AGENDA ITEM #12

Application for: Preliminary Plat

Location: Ridgway USA Subdivision, Lots 30-34

STAFF REPORT

VERIFY CONDITION OF EXISTING 36" CULVERT AND REPAIR INLET IF NEEDED.

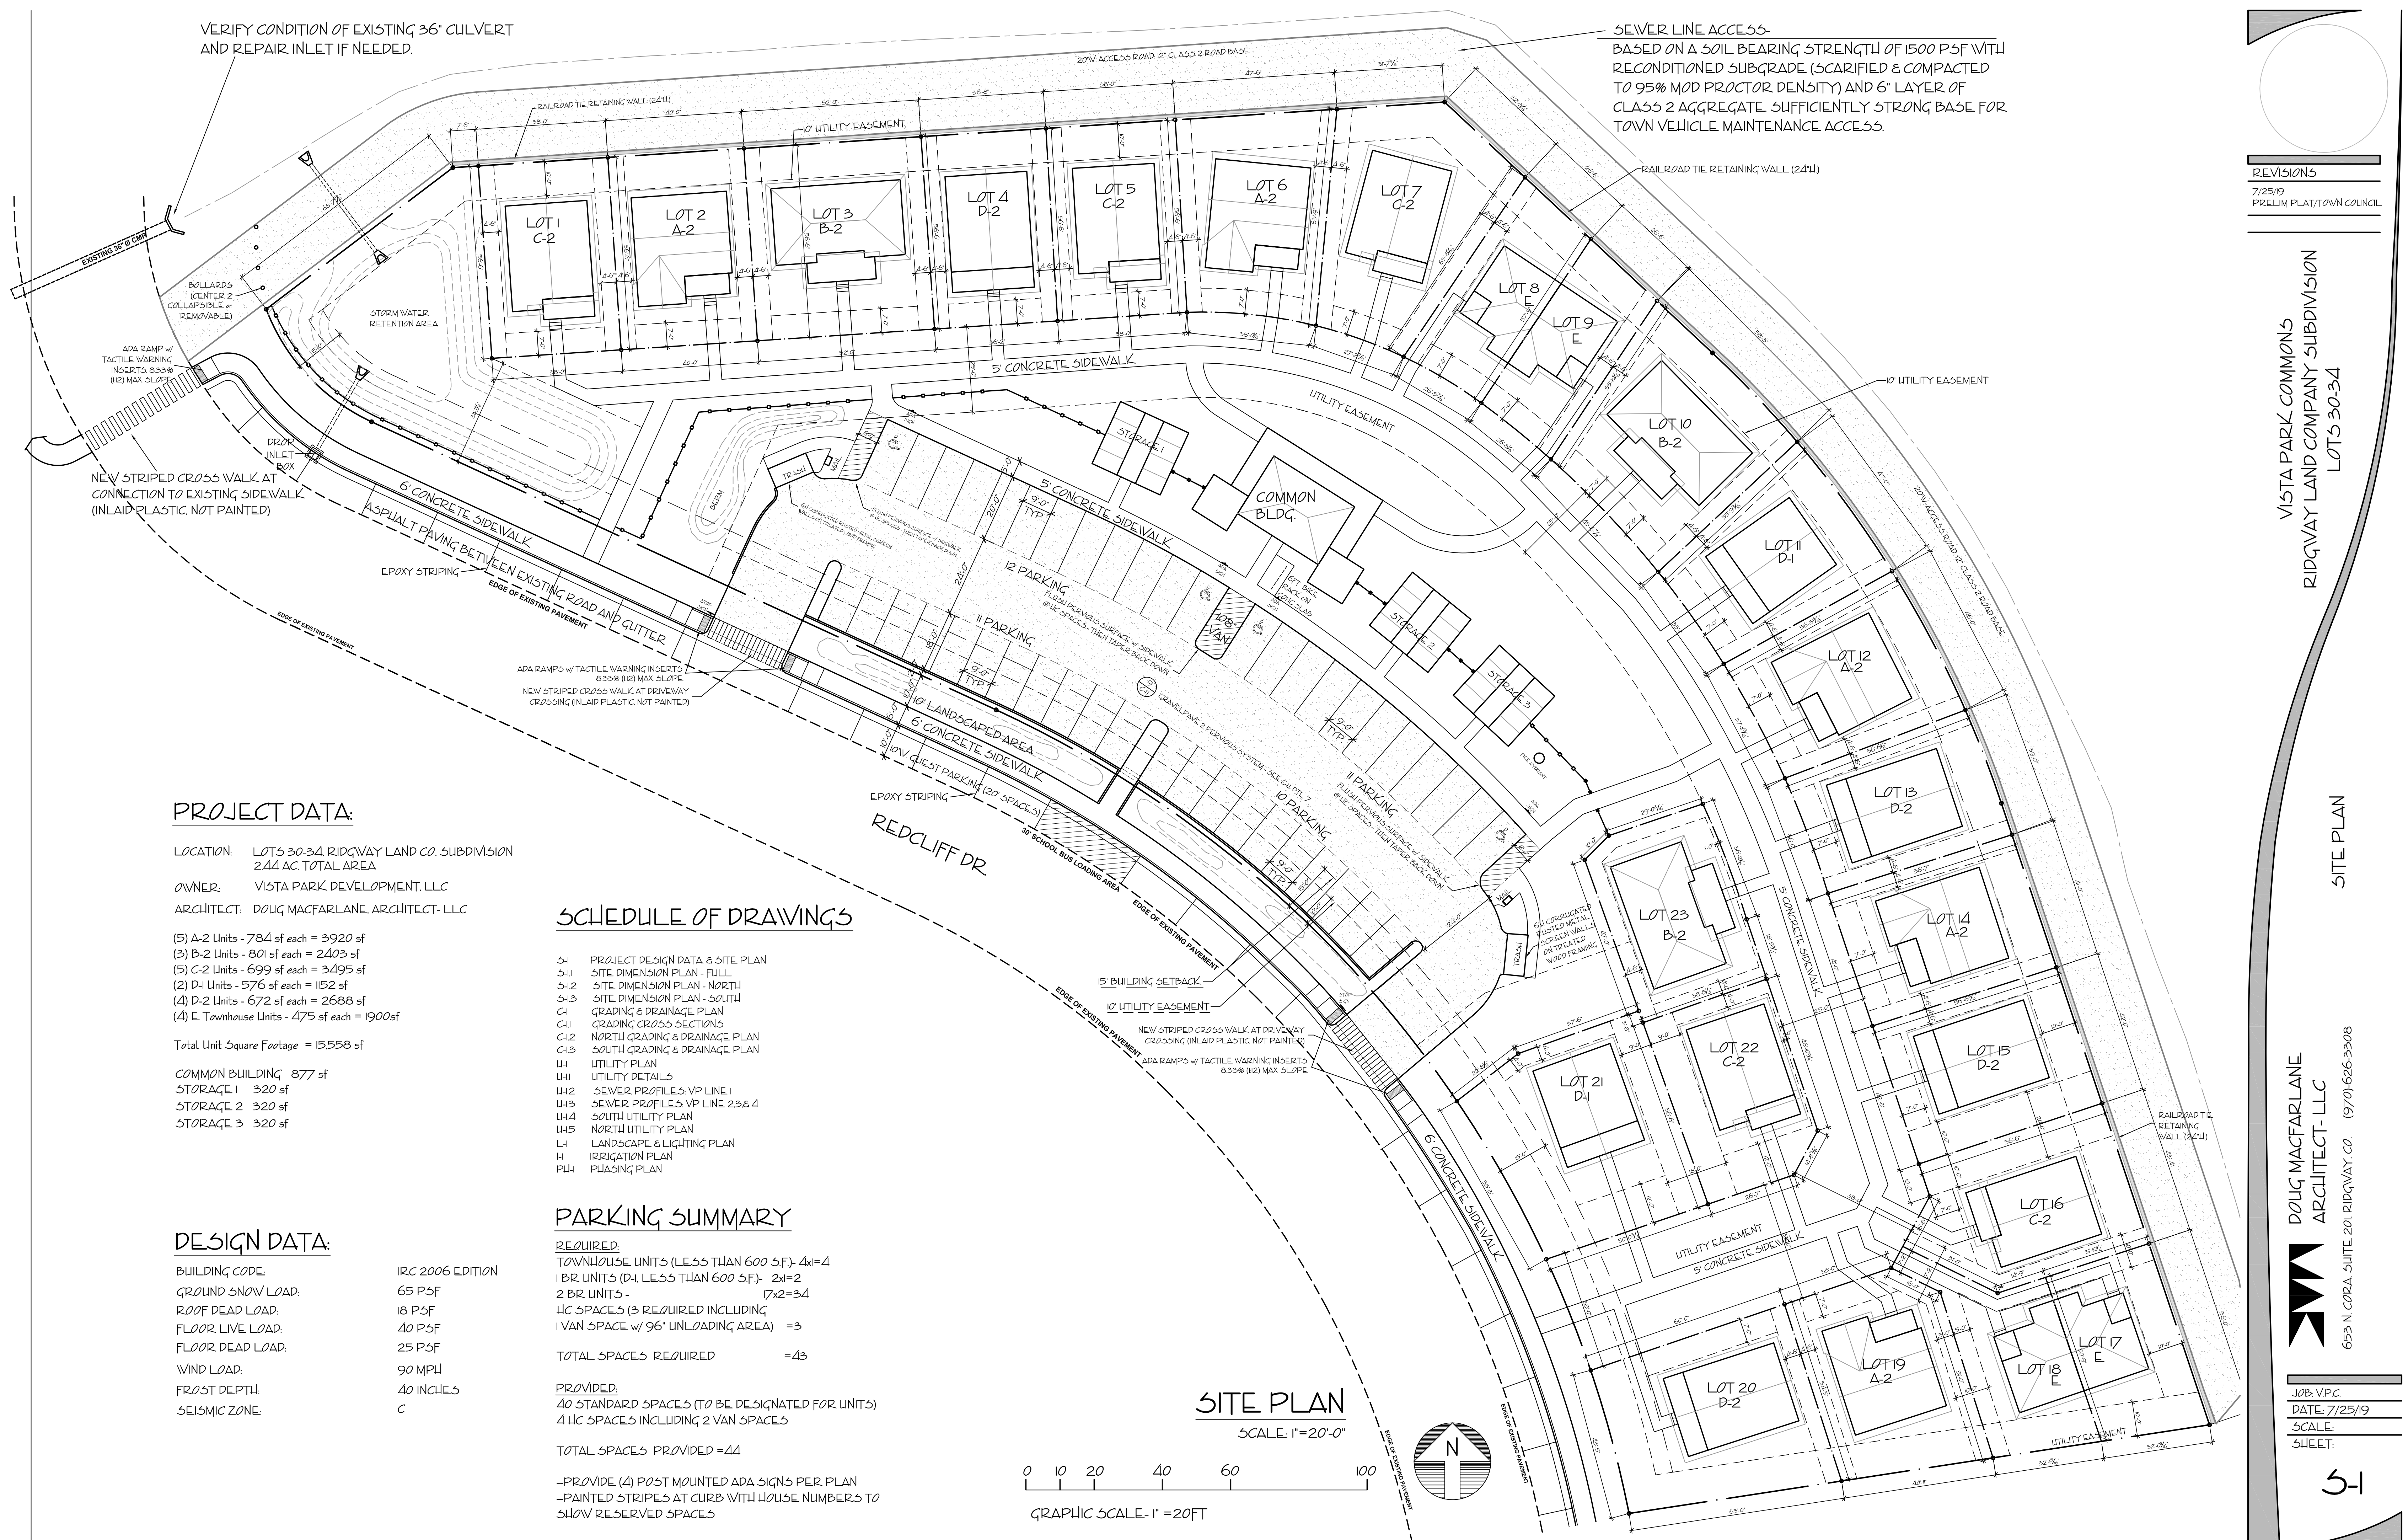
- The easements and dedication language on the plat need to be cleaned up. These easements should also be reflected the same on the civil plans. Some things that need to be looked at include:
 - The “Dedicated Utility and Drainage Easement” between lots 15 and 16 does not seem to be dedicated to the Town and there is a sewer main going through that easement area.
 - The “Dedicated Utility and Drainage Easement” north of lot 21 is to access a sewer main running between lots 21 and 21. Not sure that it is properly dedicated to the town.
 - What is 4(ii) “Service and Utility Easements”? I do not see that on the map.

Need dimensions, bearings, distances, etc. for the relocated ditch on pages 3 and 4 of the plat map. Also ensure it matches the civil plans.

Need to delete the setback lines that continue beyond where needed on lots 18-21.

- Page 4 of the plat- delete extra word under drainage easement the key.
- Regarding the Redcliff Drive ROW
 - On the curb and gutter typical drawing, please clarify what slope and width of the gutter is proposed.

C-1

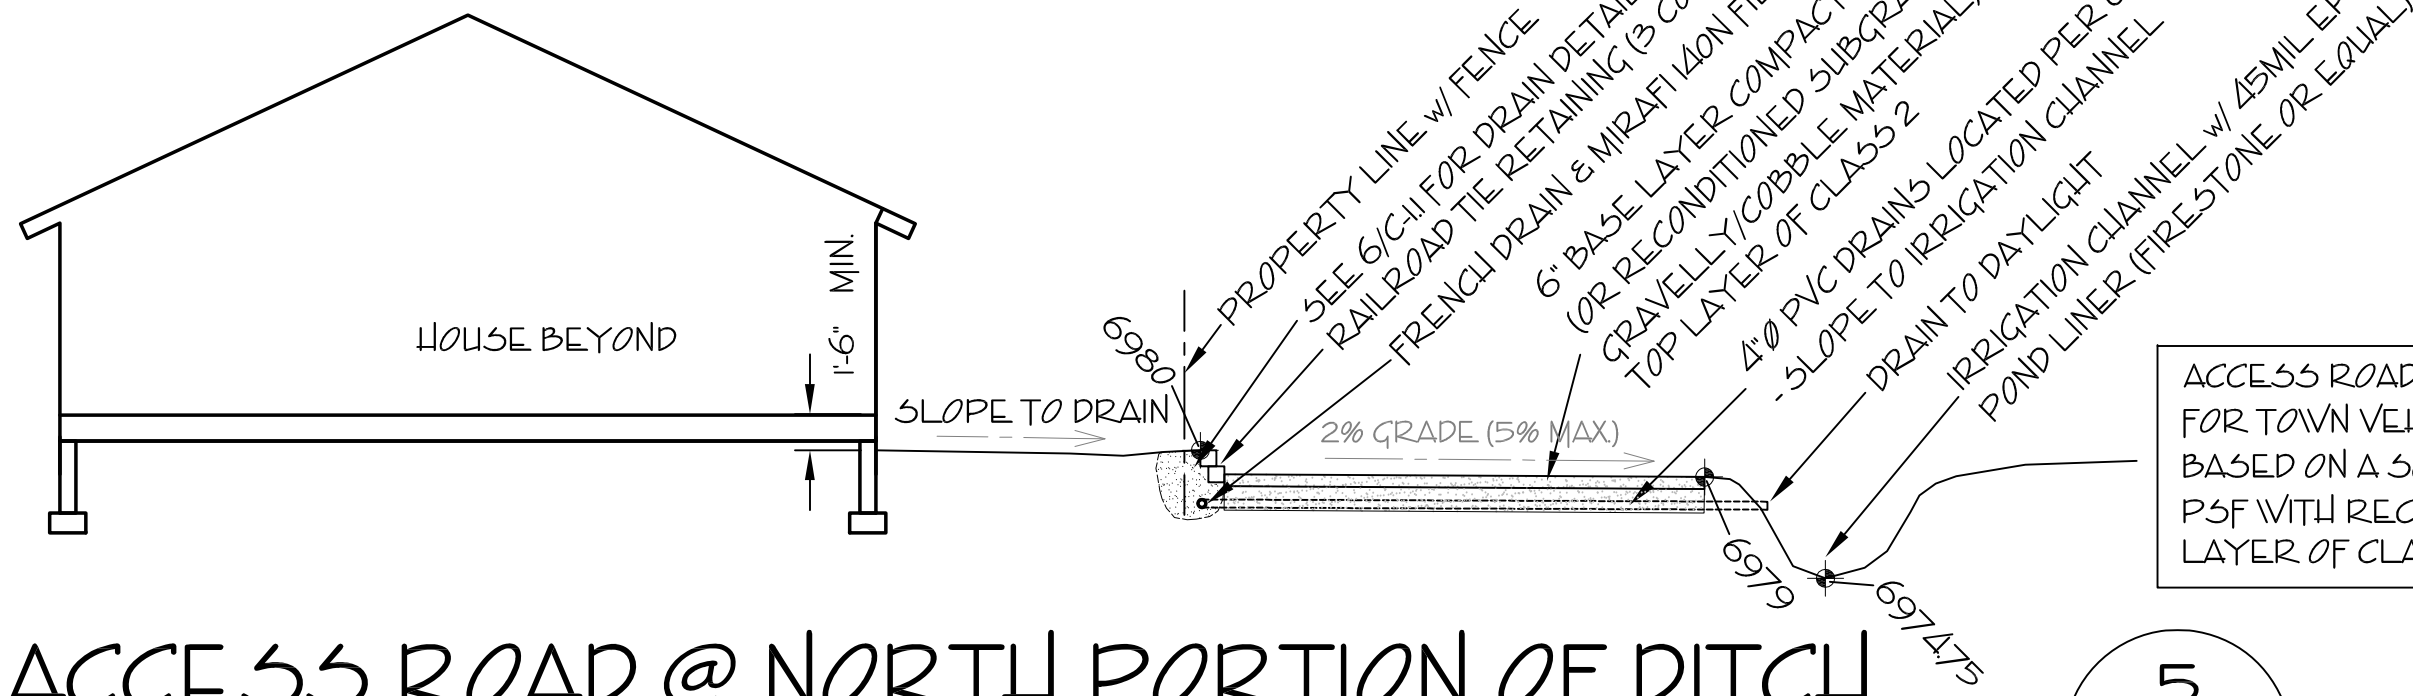
- Need sizing and calculations that demonstrate the correct flows will be detained. Are there multiple orifices? What size, elevation, entry conditions? What is designed to come out of each with how much head? Etc. Please clarify the note on sheet C-1 about the 4" outlet control.

- The inlet box detail on sheet S1.1 shows a 4' square box while on sheet C-1 it is called out as a 3' square box. It should be 4' square and must be traffic rated. It looks like the depth of the box in the gutter flow line is 2.06 feet deep including the grate and the pipe exiting the box is 18" without the grate. The pipe will take up the full depth of the concrete weakening the concrete. Does that impact the traffic rating?

GRADING SECTIONS

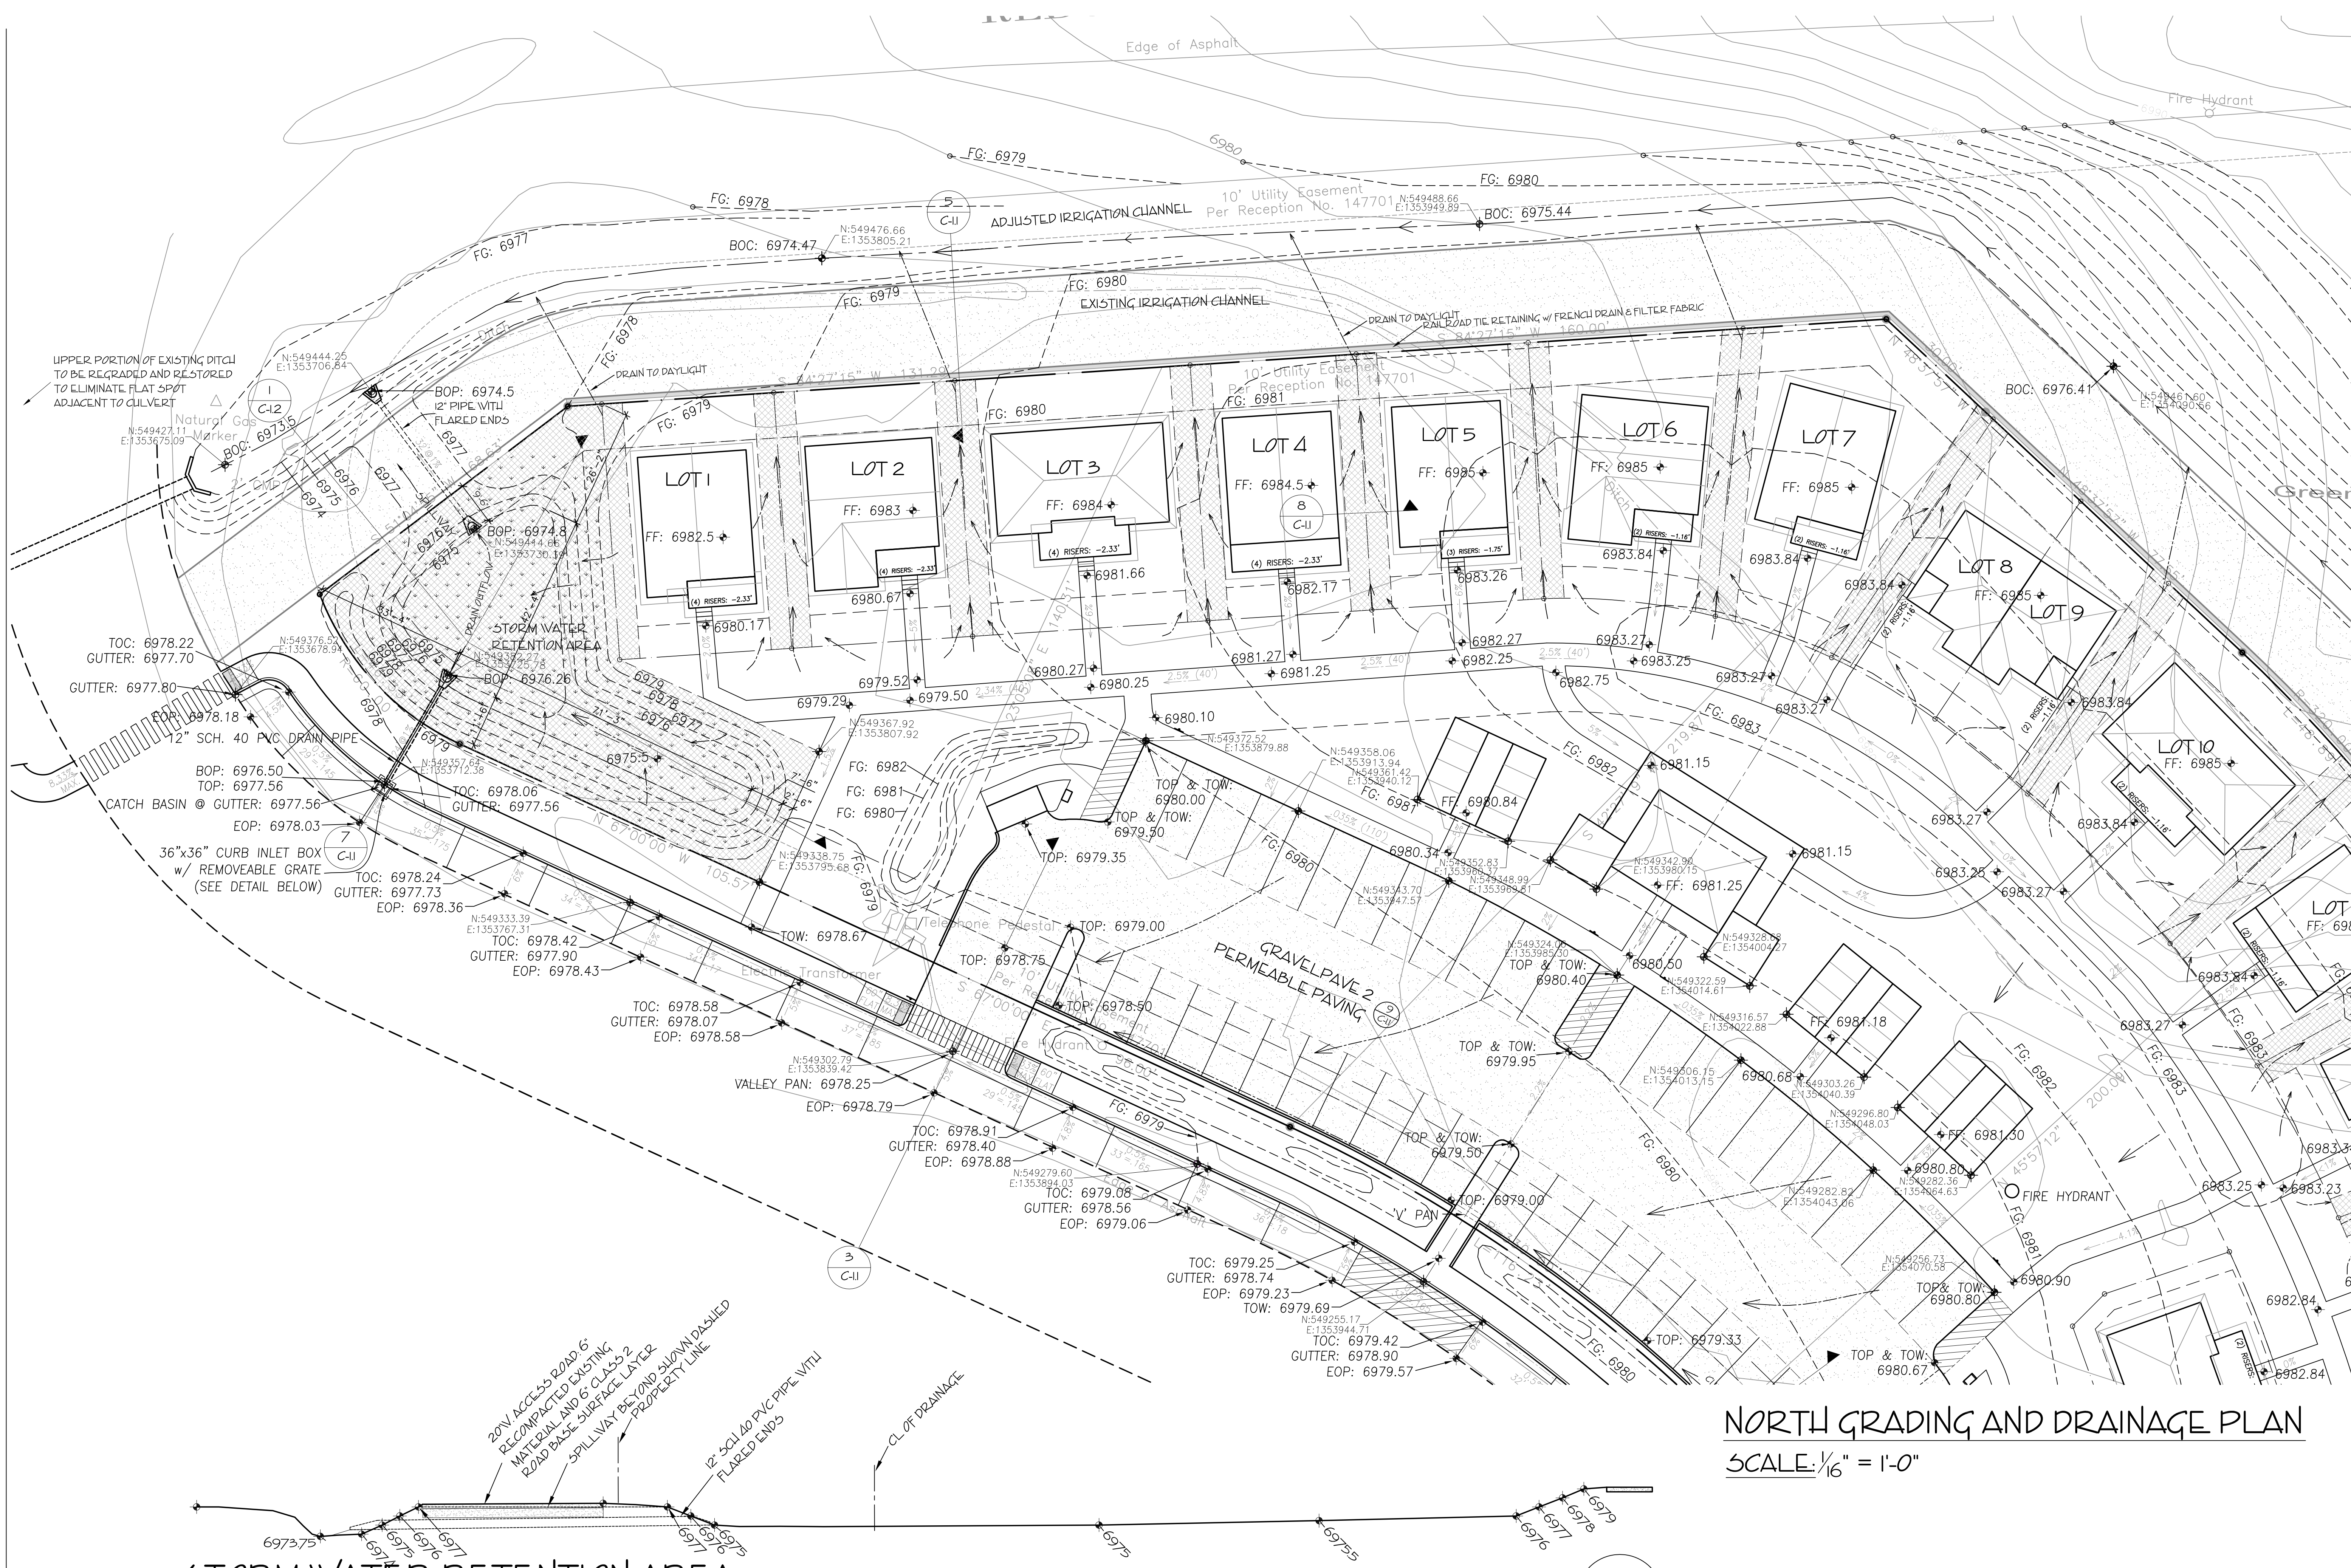
- On the detail on page C-1.1 is 24" tall the tallest one of these walls would be?
 - The finished ground elevations from lots 4 to 17 are the same in the back yet the finished floors of the units vary by a couple of feet, some by about 4'. How will this work? Applicant said they adjusted the grades.

- Sheet C-1.1: Section 8 calls for a 2% slope down from the building for 5 feet that is then to be flattened into a swale. That is a drop of 0.10'. How does that work?

- How does water get out of the south side of the south bulbout at the north entry to the parking lot? Is there a drain box proposed?
- Sheet C-1.1: Please add specs (brand or cut sheet) for the filter fabric (detail 6) – we want to be sure it will not plug the drain. Please add specs (brand or cut sheet) for the liner material (detail 5) - how will you clean the ditch without destroying a liner?

- Driveway cross sections need to be refined. Added on page C-1.1. The south valley pan has a grade break at the middle of the pan N/S and is flatter on the downstream side which will slow the water in the middle of the pan. Is there a purpose for this? The cross sections have an architectural scale and no stationing. This has taken a lot of the Town Engineer's time to review. Section 3/C-1.1 is showing a second valley pan to the east of the main pan in the pervious pavement. Staff is not seeing it on the plans on C-1. ~~Are the applicants proposing a concrete valley pan with pervious pavement on either side?~~ The only valley pan elevations found are at the middle of the valley pan, we need more spot elevations. It but looks like the 0.5% slope along the gutter carries thru the valley pan. It's very hard to get concrete that flat without creating bird baths. How will one locate the valley pans in the field? On page C-1, it is okay that you used the town typical drawing for the valley pan but please remove the town letterhead so it doesn't look to be our standard.
